AGENDA

Regular Town Board Meeting (VIRTUAL)

February 15, 2021 - 6:00 PM

Cook Farm Subdivision Sketch Plan

JOB NO.
46244
SHEET NO.
C-400

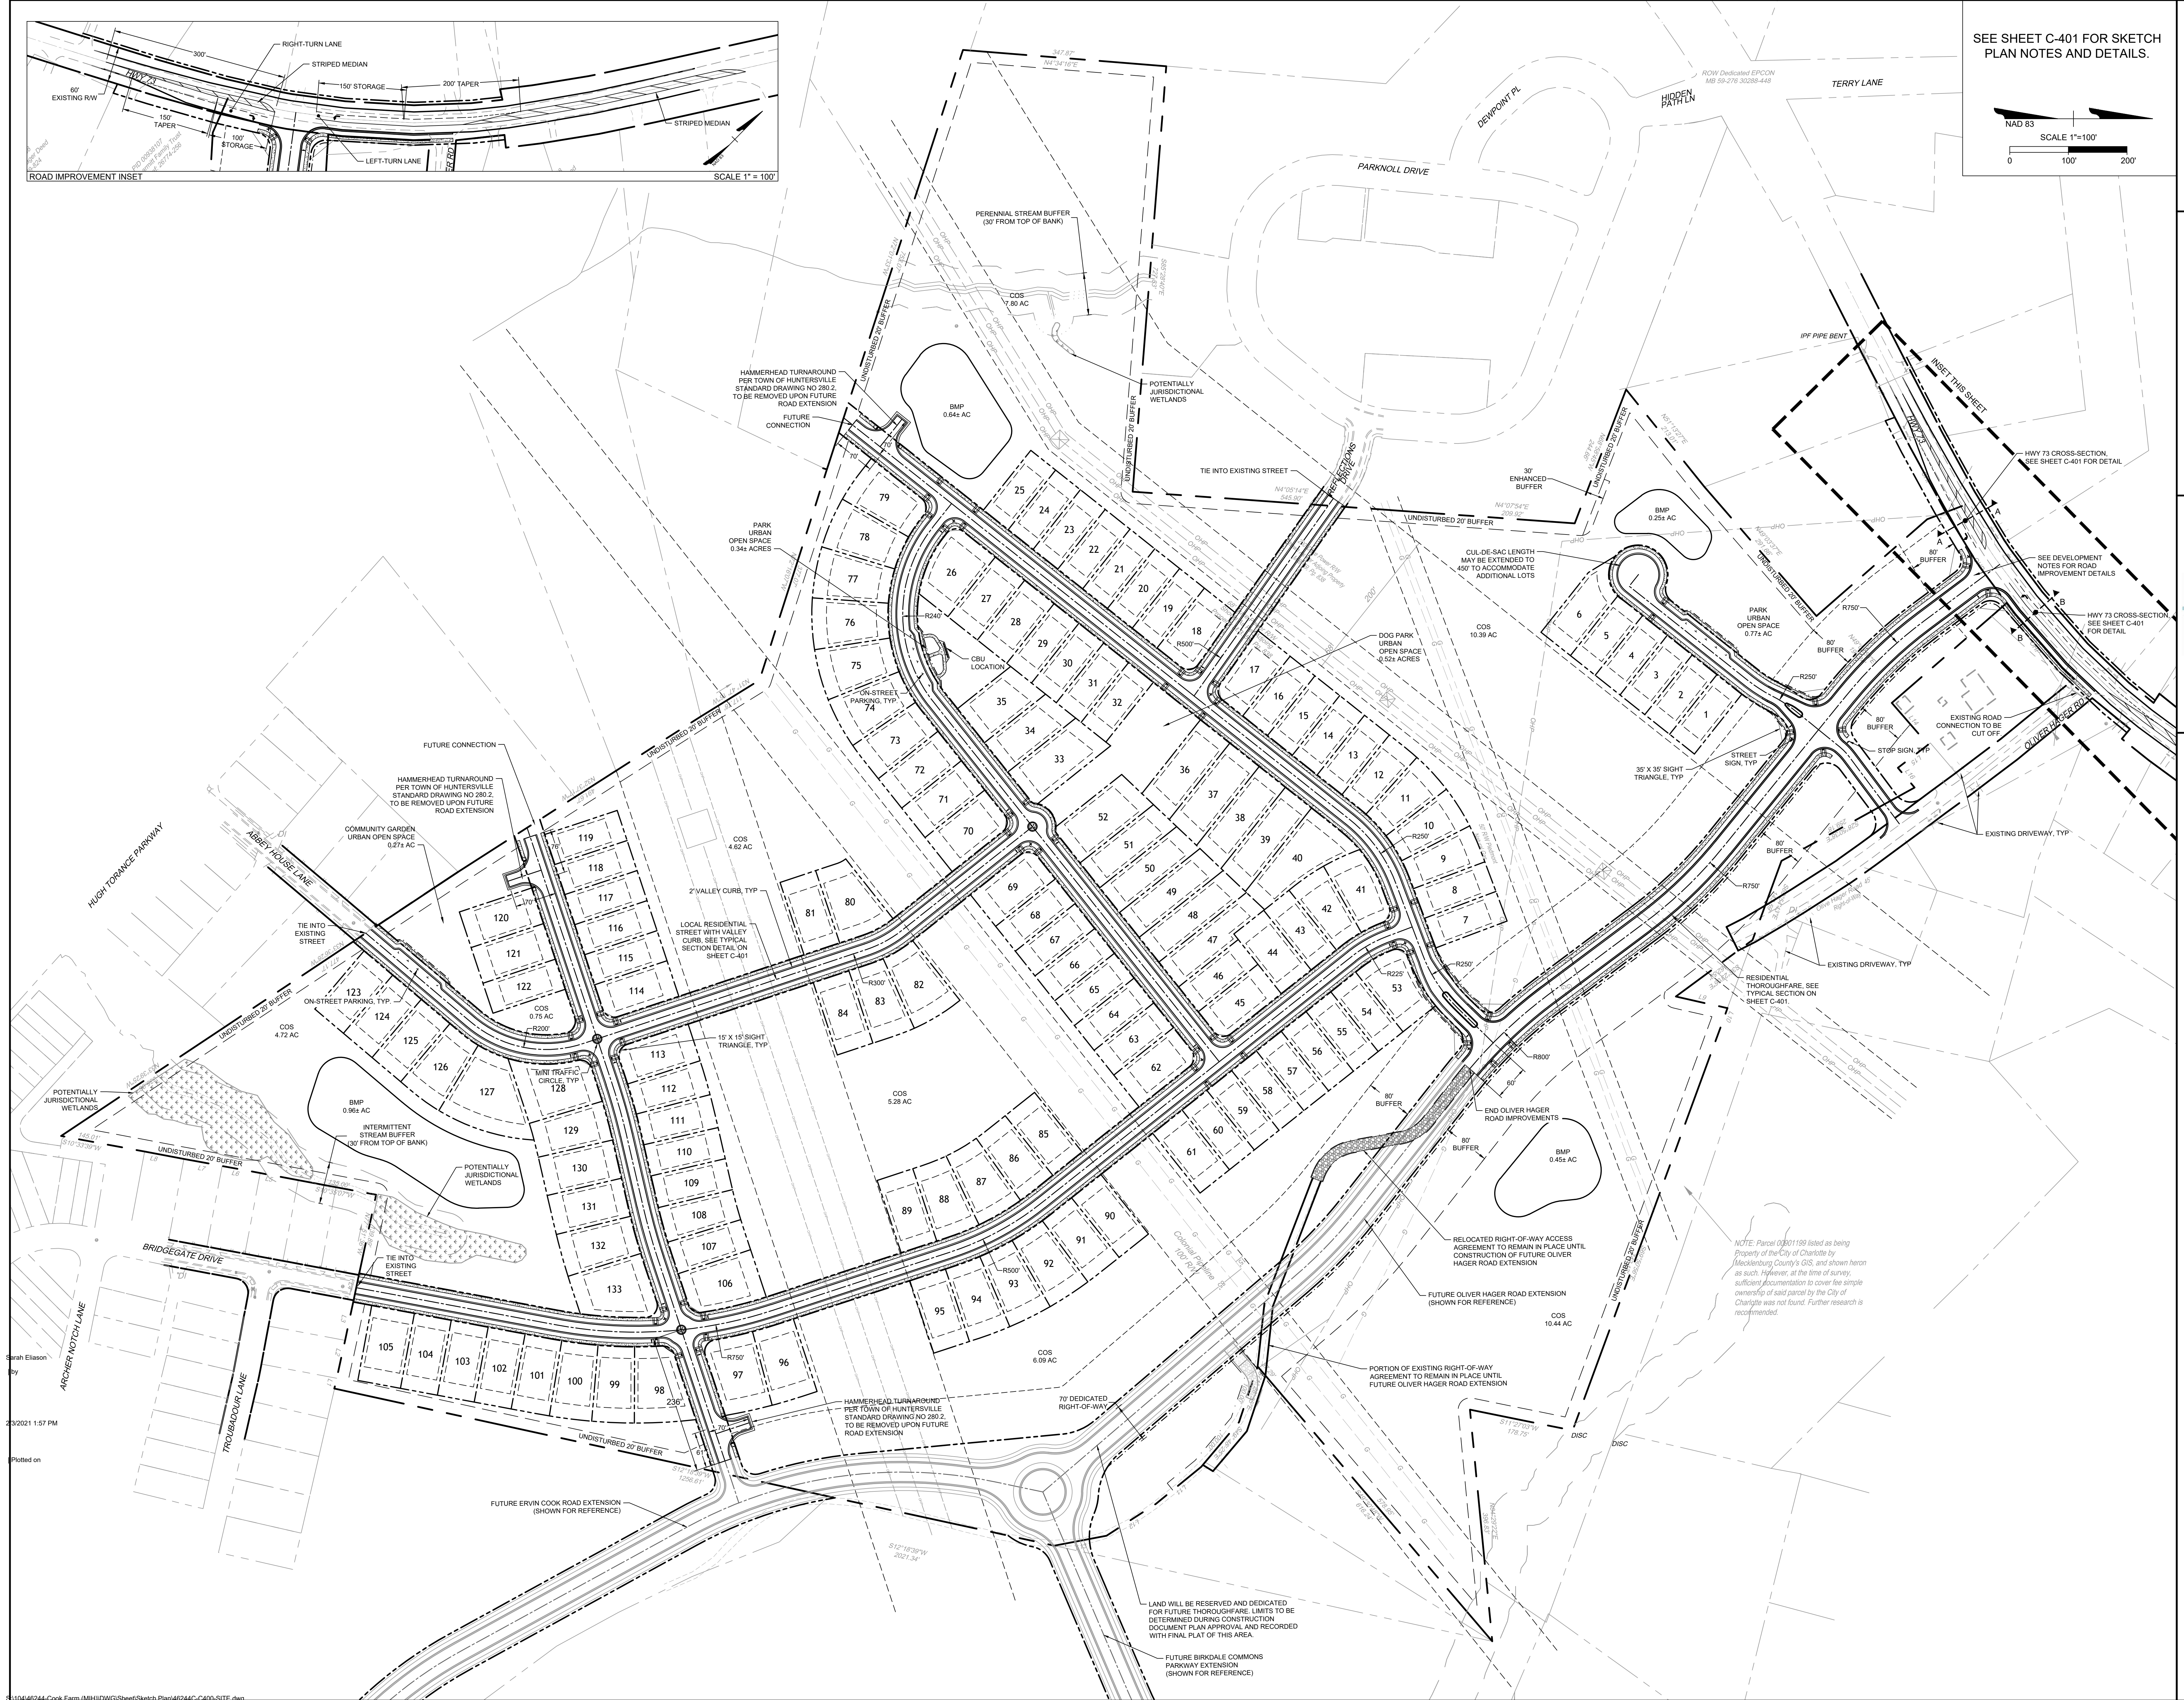
14. ~~Modification requests for two block lengths that exceed 800 ft. have been added to Plan Sheet C-401. Deleting the width of the utility easements from the block lengths brings them into compliance – modification requests are no longer required.~~ **Modification requests for block length have been deleted;**

- A modification request for a 250-foot cul-de-sac can be supported by Staff, as the area in question is isolated by several utility easements;
- Delete two block length modification requests, as Staff indicates they are not needed (see Sheet C-401);
